Access Compliance Report

Public Rights-of-Way

(Curb Ramps)

Intersection ID: 12971	Main Street: HERONWOOD_LN	Cross Street: PENCE_POND_LN	Location: S
ADA ID: 6D068C6BEE97	Ramp Type: Perp	Initial Pass/Fail: Fail	Overall Compliance: No
Severity Score: 8.75			
Codes/Mitigation Info/Possible Solution		Field Measurements/Component Compliance

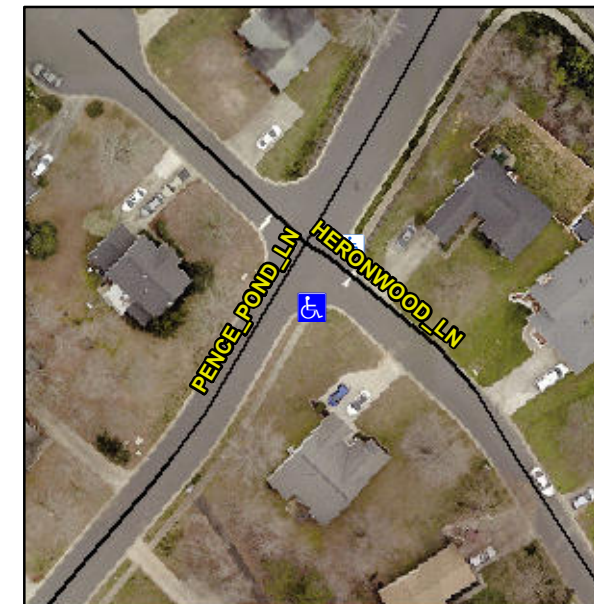
Not Found, R304.5.1

Compliance	Description	Data	Compliance	Description	Data
N/A	Ramp Length (in)	44.0	Yes	Ramp Slope (%)	7.7
No	Ramp Width (in)	47.5	Yes	Ramp XSlope (%)	0.8
N/A	Flare Type LT	N/A	N/A	Flare Type RT	N/A
N/A	Flare Slope LT (%)	N/A	N/A	Flare Slope RT (%)	N/A
N/A	Flare Traversable LT?	N/A	N/A	Flare Traversable RT?	N/A
N/A	Landing Length (in)	N/A	N/A	DWS Provided?	N/A
N/A	Landing Width (in)	N/A	N/A	DWS Contrast?	N/A
N/A	Landing Slope (%)	N/A	N/A	DWS Length (in)	N/A
N/A	Landing X Slope (%)	N/A	N/A	DWS Full Width?	N/A
N/A	Landing Curb? (Y/N)	N/A	N/A	DWS Offset (in)	N/A
N/A	Shared Landing?	N/A			
N/A	Gutter Ponding?	N/A	N/A	Gutter Slope (%)	N/A
N/A	Gutter Lip Ht (in)	N/A	N/A	Gutter X Slope (%)	N/A
N/A	Painted X Walk1?	No	N/A	Painted X Walk2?	N/A
	X Walk 1 Direction	To NE		X Walk 2 Direction	N/A
N/A	X Walk 1 Width (in)	N/A	N/A	X Walk 2 Width (in)	N/A
	X Walk 1 Slope (%)	1.1		X Walk 2 Slope (%)	N/A
	X Walk 1 X Slope (%)	3.6		X Walk 2 X Slope (%)	N/A

Remove & Replace Entire Ramp.
